CROSSROADS MIXED USE FILING NO. 1

CONSTRUCTION PLANS

DECEMBER 2021

EL PASO COUNTY FILE NO. SF 21-029

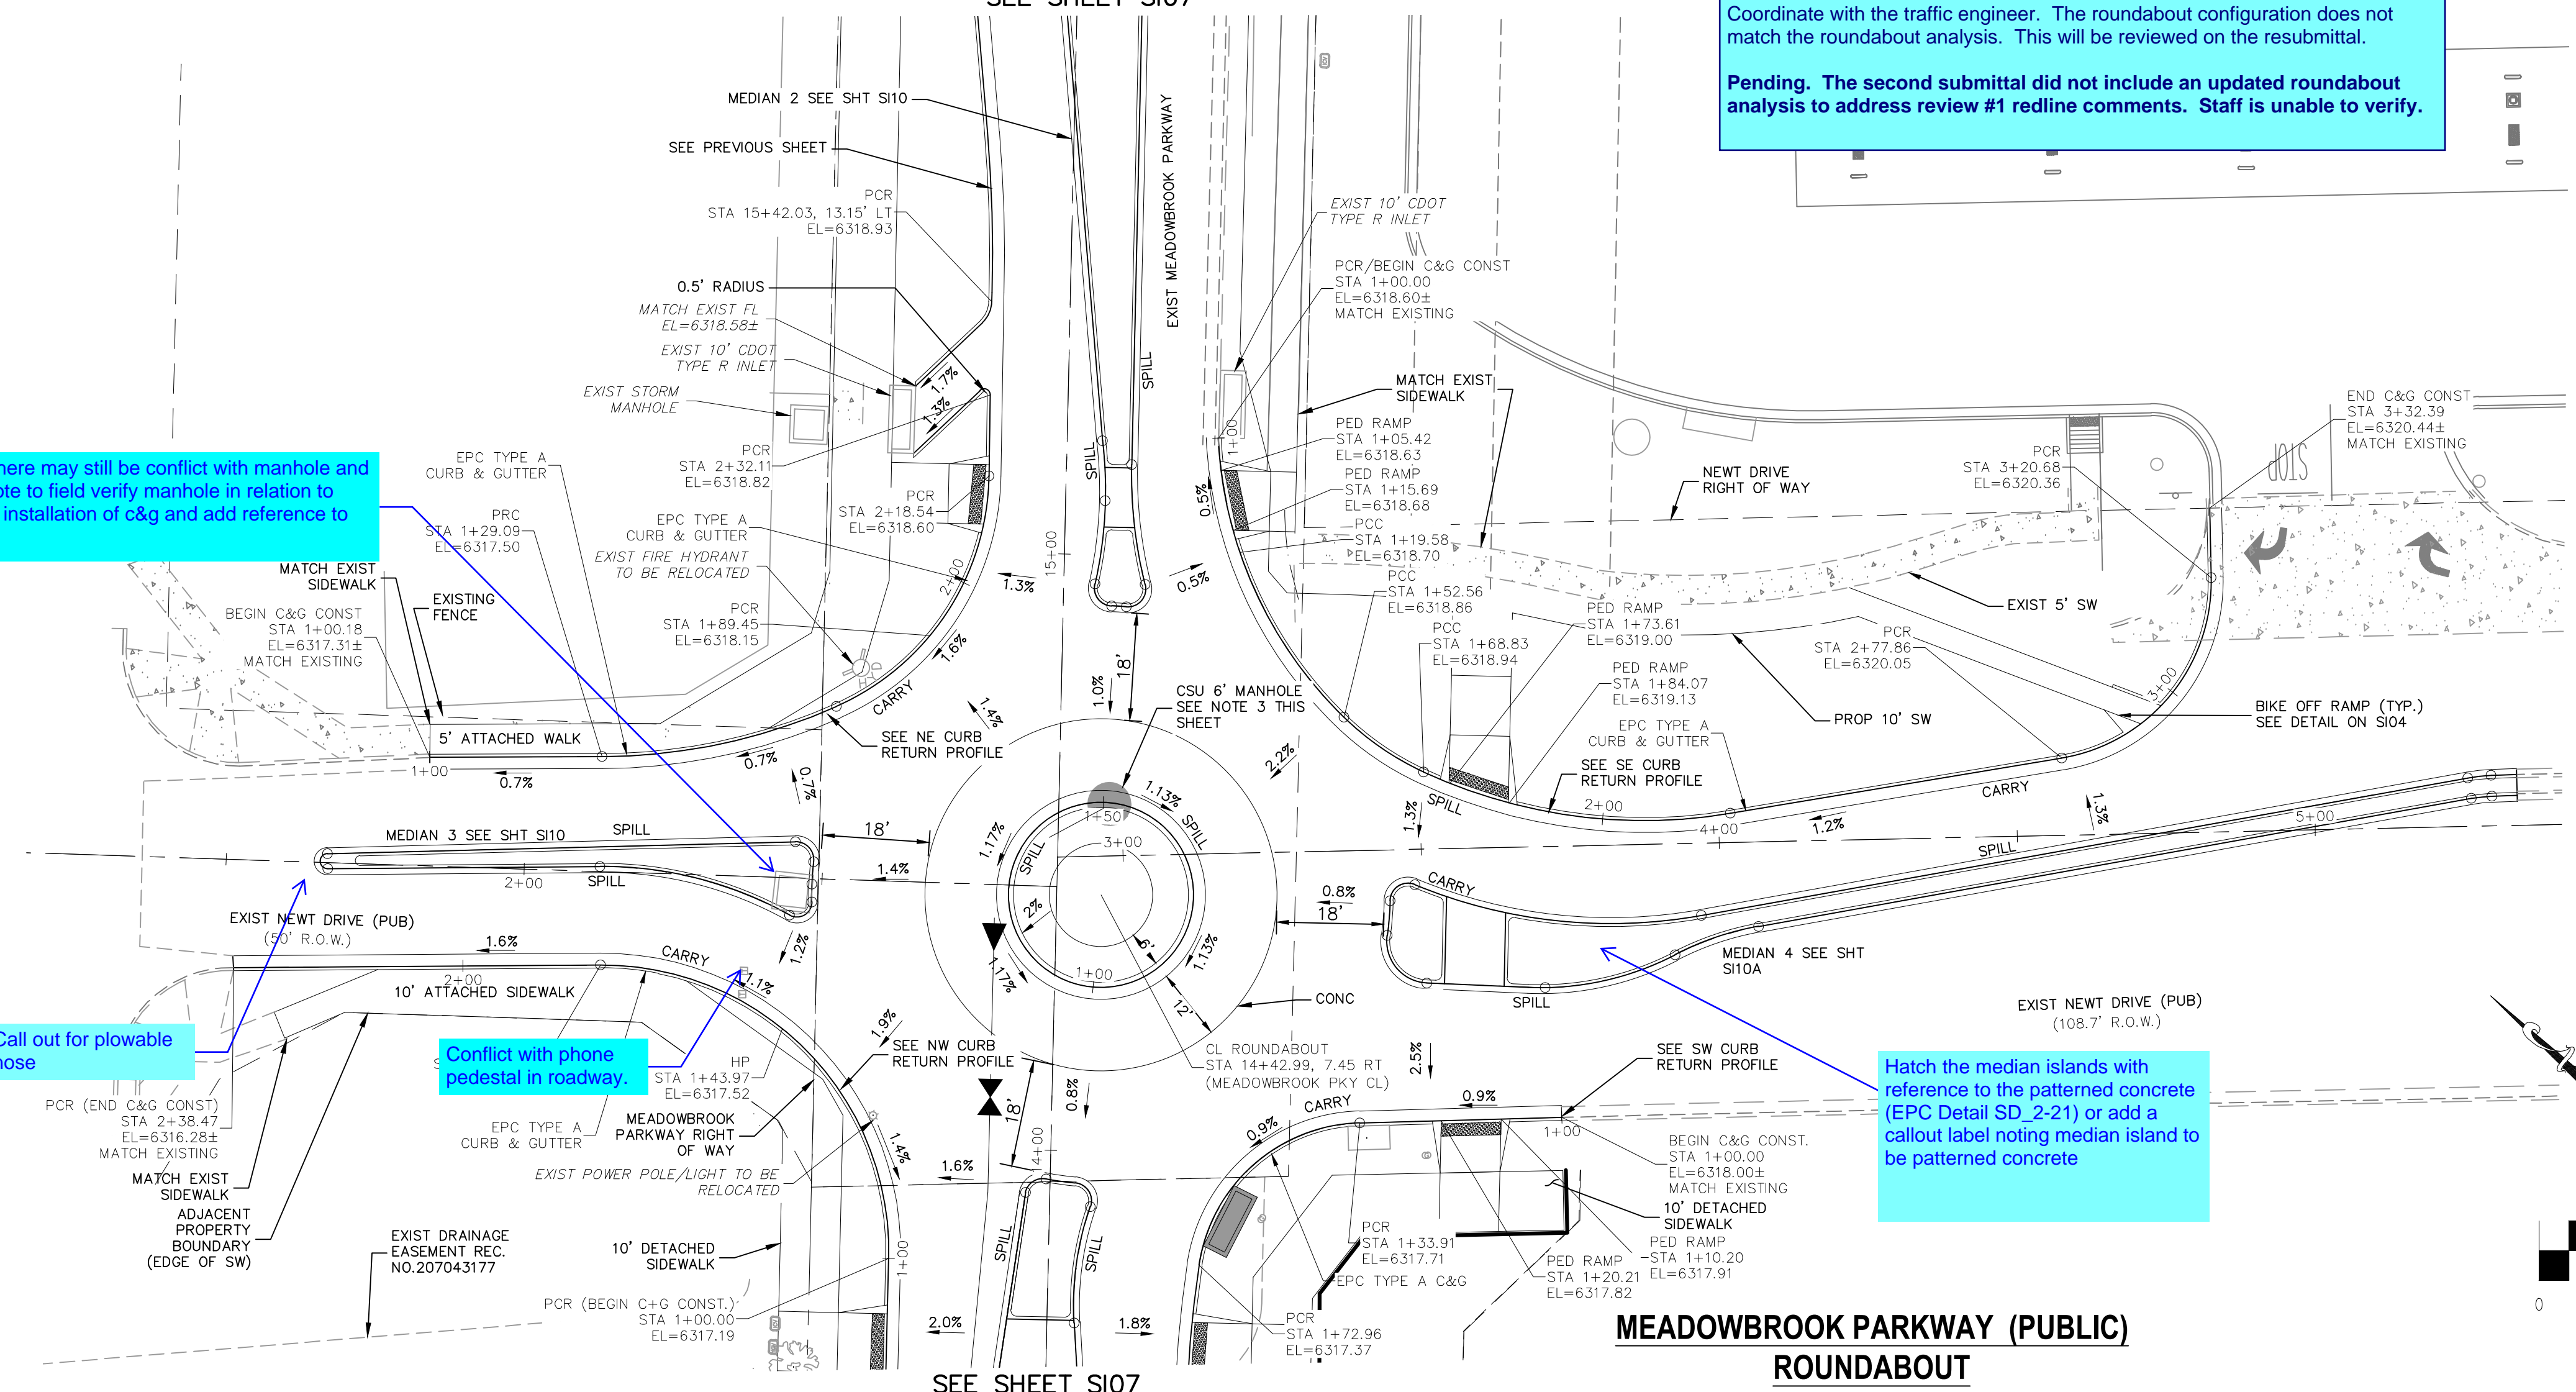
Hatch the median islands with reference to the patterned concrete (EPC Detail SD 2-21) or add a callout label noting median island to be patterned concrete

Provide lighting plans within the roundabout intersection. Unresolved

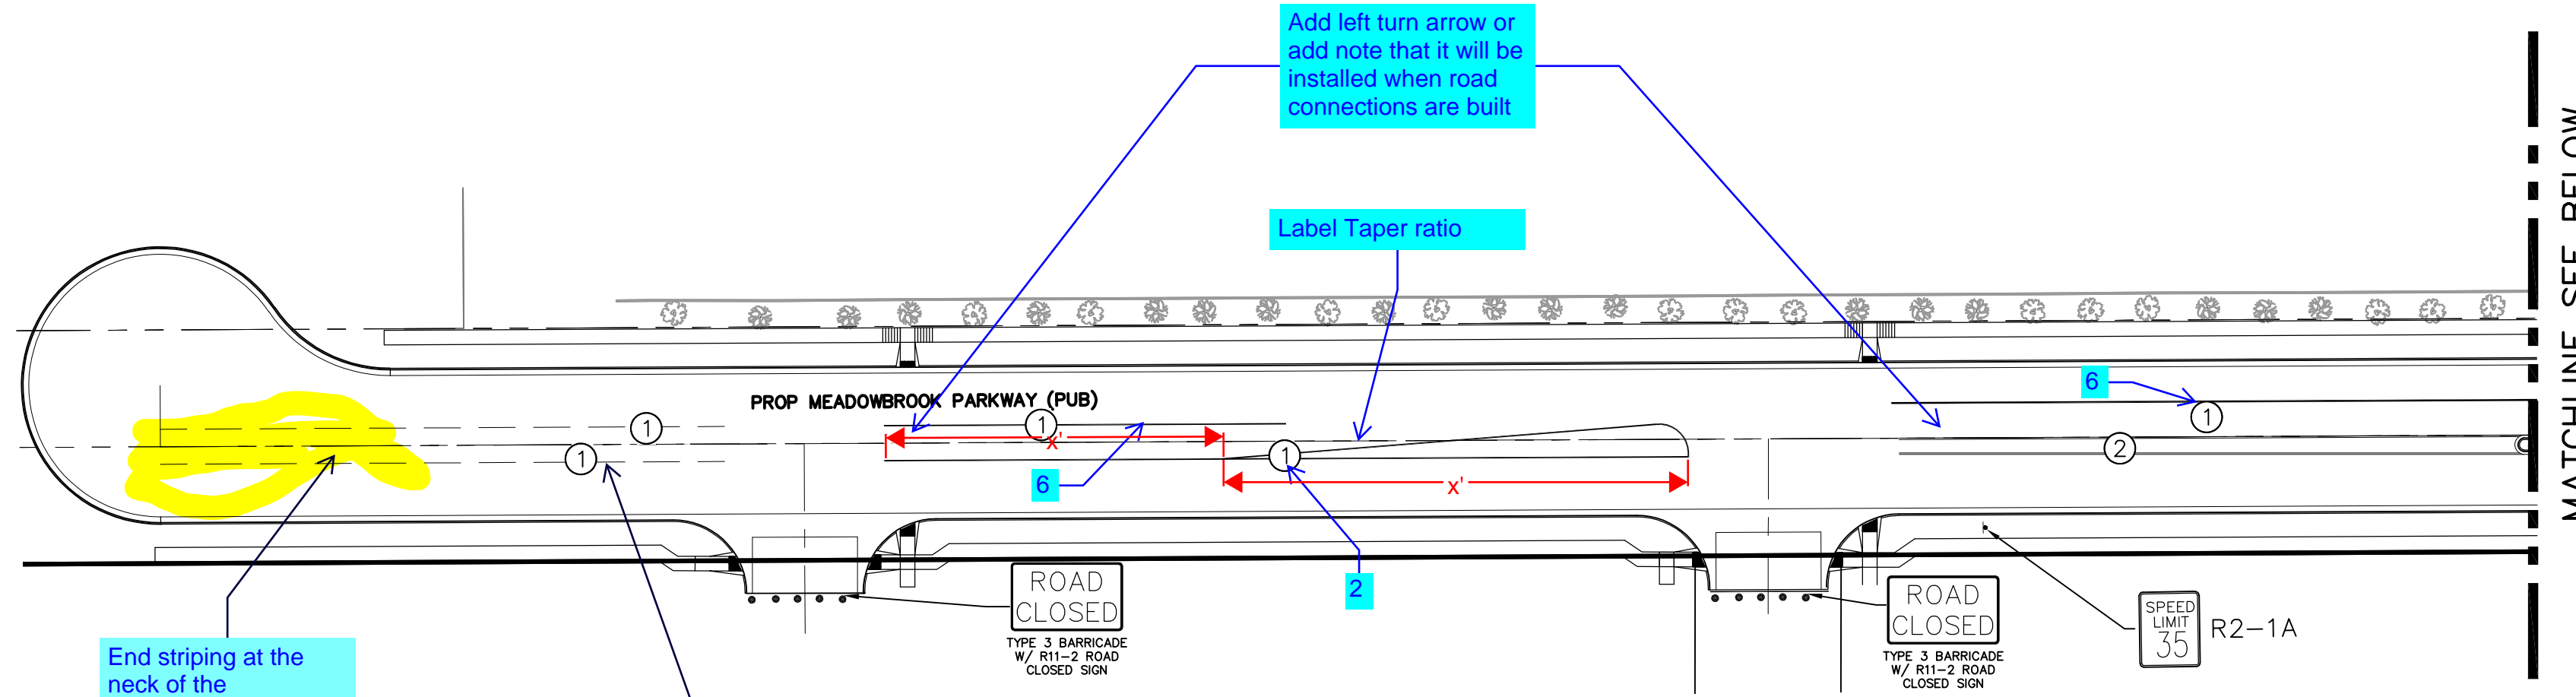
Turn on centerline stationing for reference

CROSSROADS MIXED USE FILING NO. 1
 SIGNAGE AND STRIPING PLAN
 PROJECT NO. 18-003
 DATE: 11/01/2021
 SCALE: HORIZONTAL: 1"=50' VERTICAL: N/A
 DESIGNED BY: CLP
 DRAWN BY: CLP
 CHECKED BY: VAS
 SHEET 12 OF 23
 S111

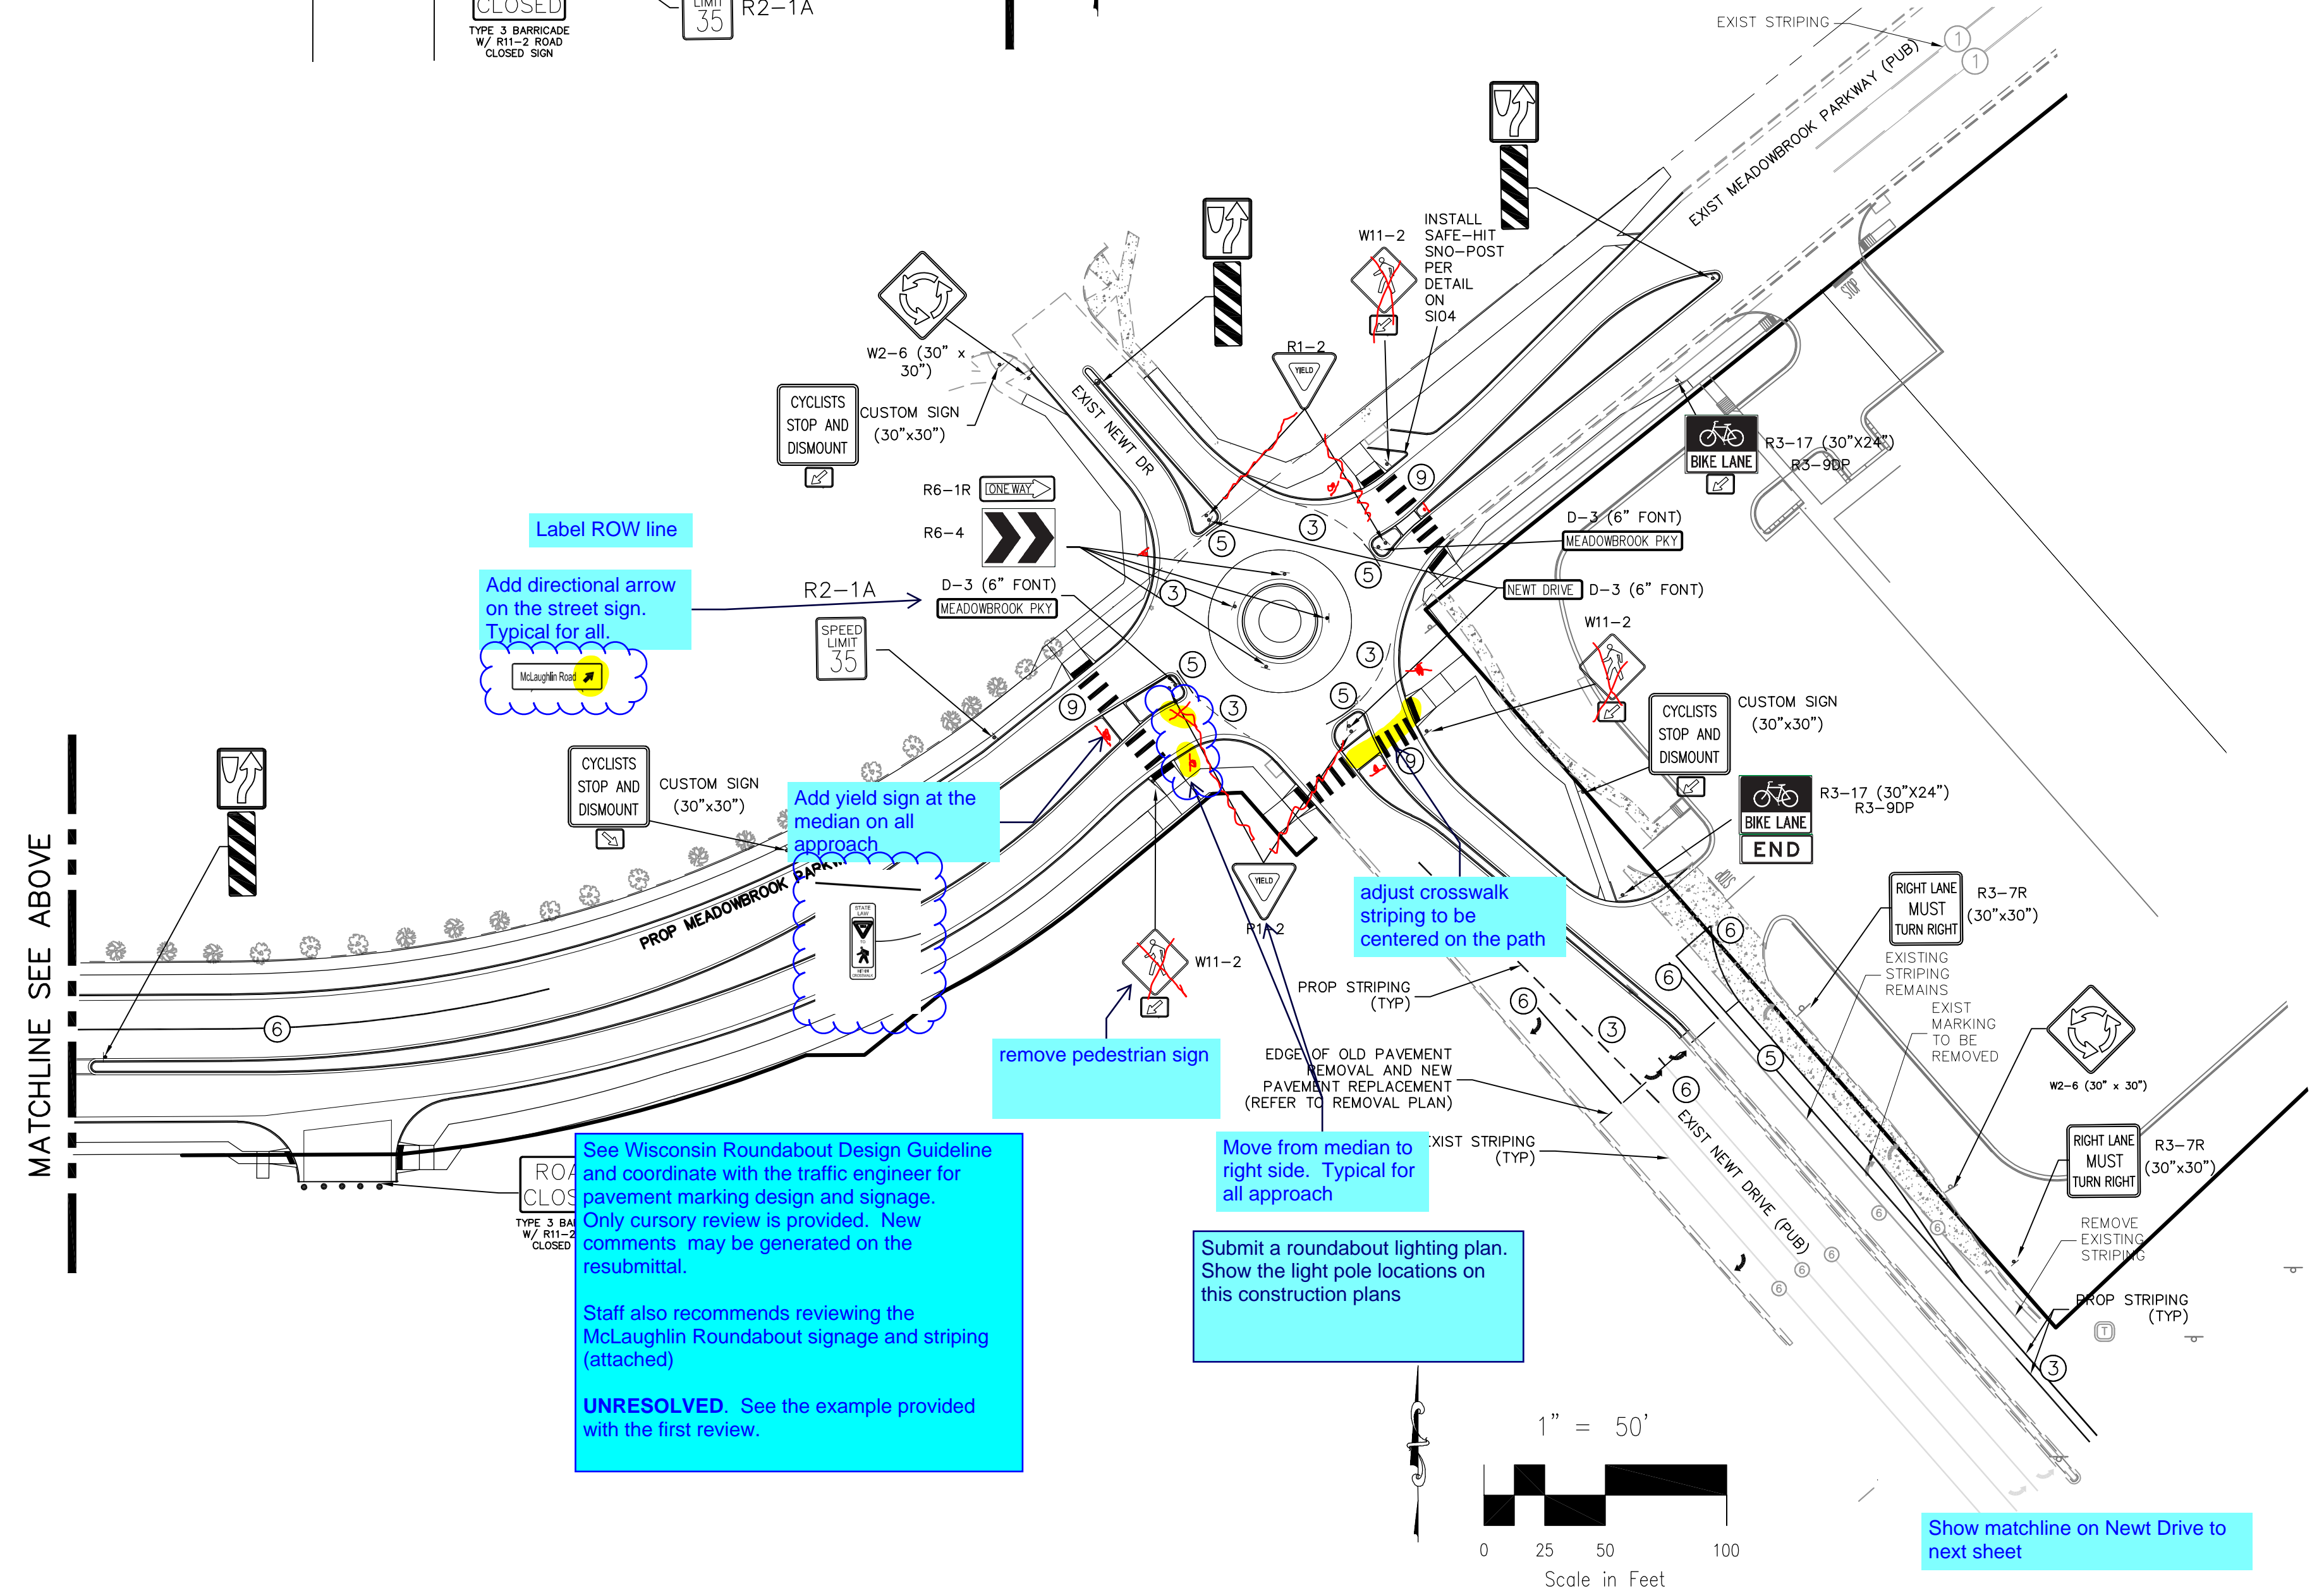
Label begin/end station of striping and linear feet. Typ all striping. See example to the left

US HIGHWAY 24 - ROADWAY IMPROVEMENTS

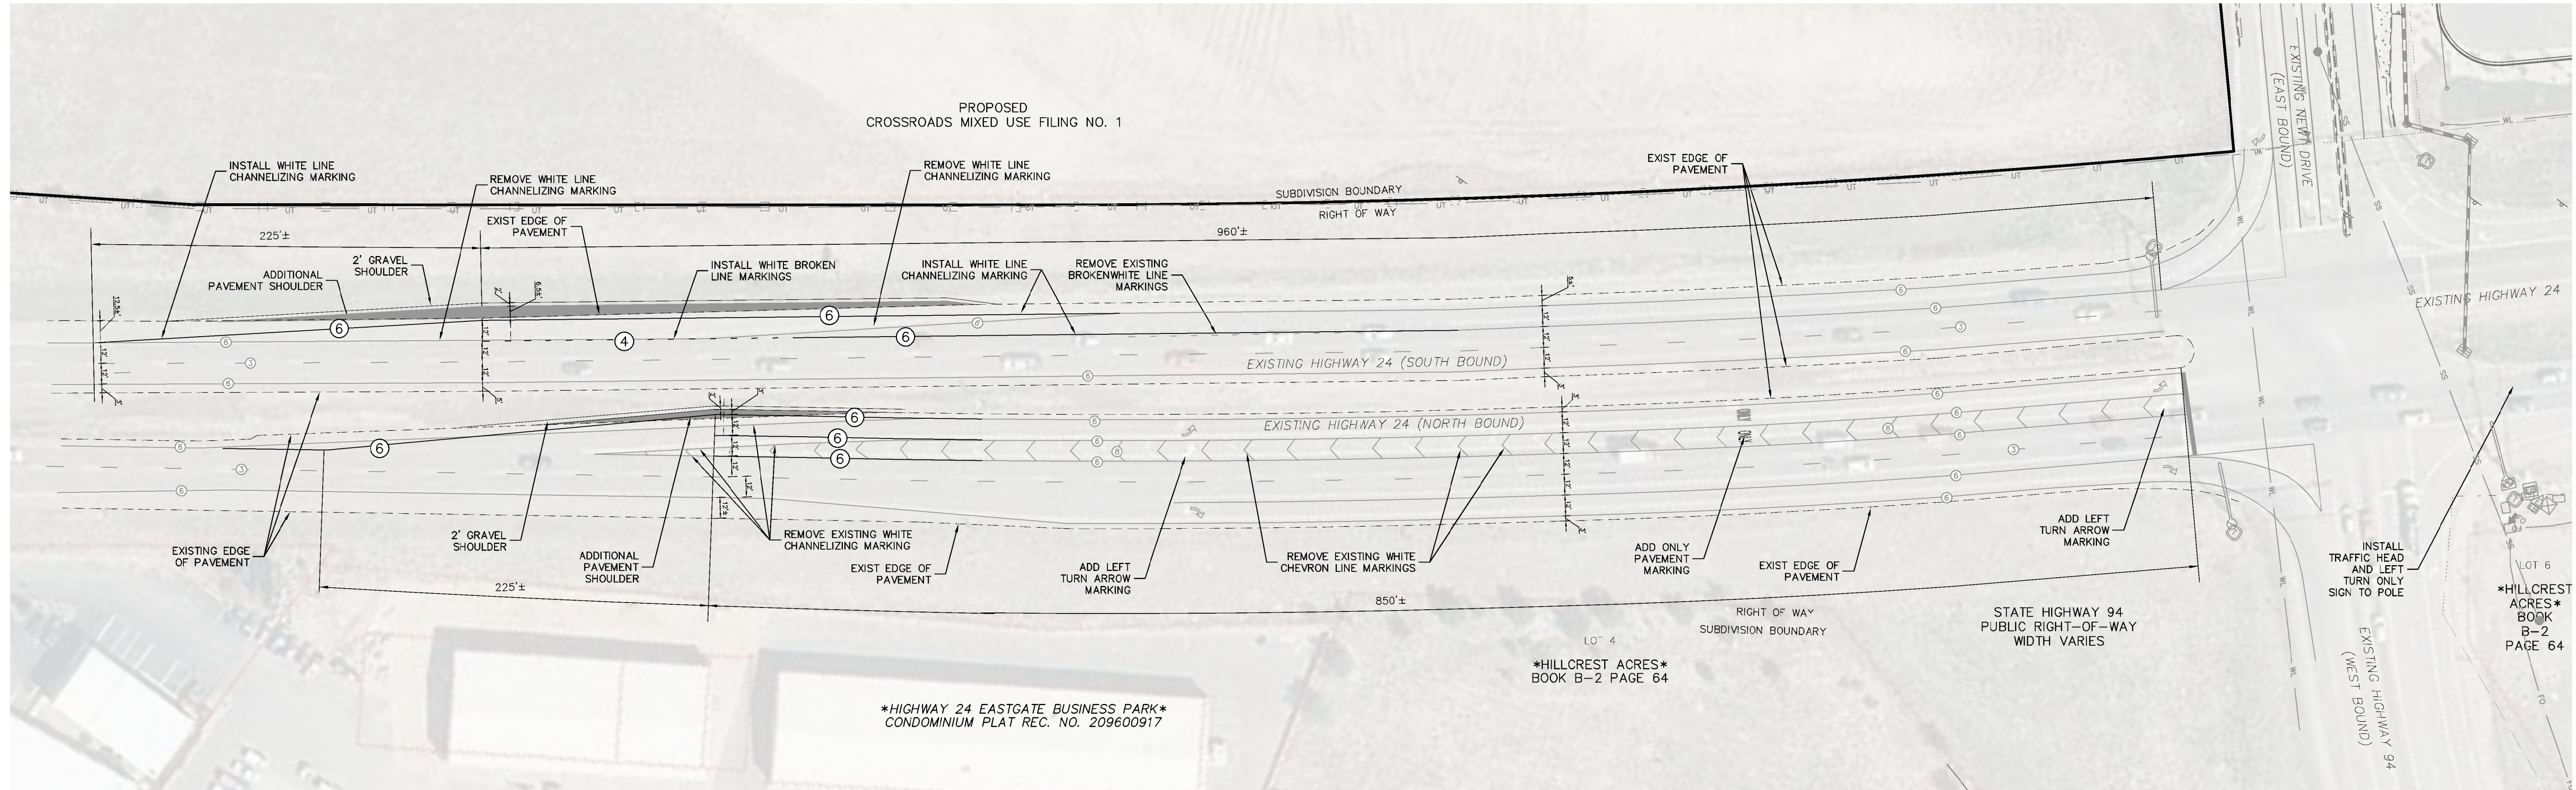
County request a copy of the plans for our records and verifying consistency at the Newt Drive intersection.

Review #2: Remove from plan set or add a large note along the lines of "For Information Only. Not a part of the Construction Plans" CDOT improvements needs to be submitted directly to CDOT for their review and approval. The County requests a copy of the approved plans for our records.
